**Subject** ▶ Change on motor housing

**For Models** ▶ JR3020 and 8406C

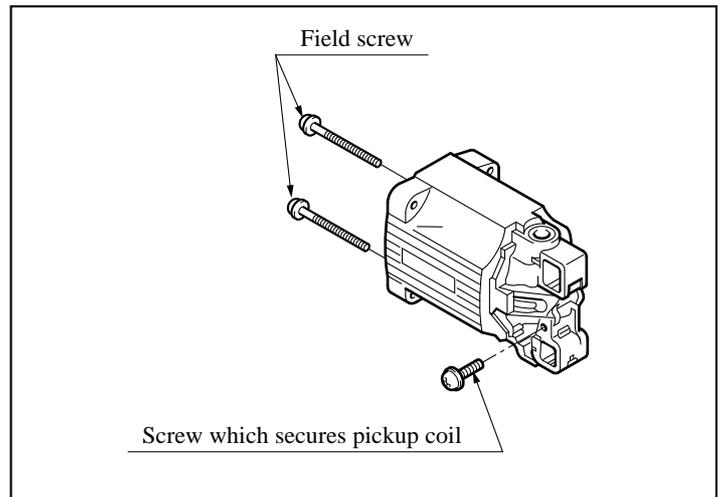
**Description** ▶ 1. The ribs of the motor housing will be changed from 2 mm (3/32") to 5 mm (3/16") in width.

- 2. The field screws will be changed from pan head screws M5x65 to tapping screws PT5x65.
- 3. For 8406C only  
The pan head screw M4x16 which secures the pickup coil will be changed to a tapping screw PT 4x18.
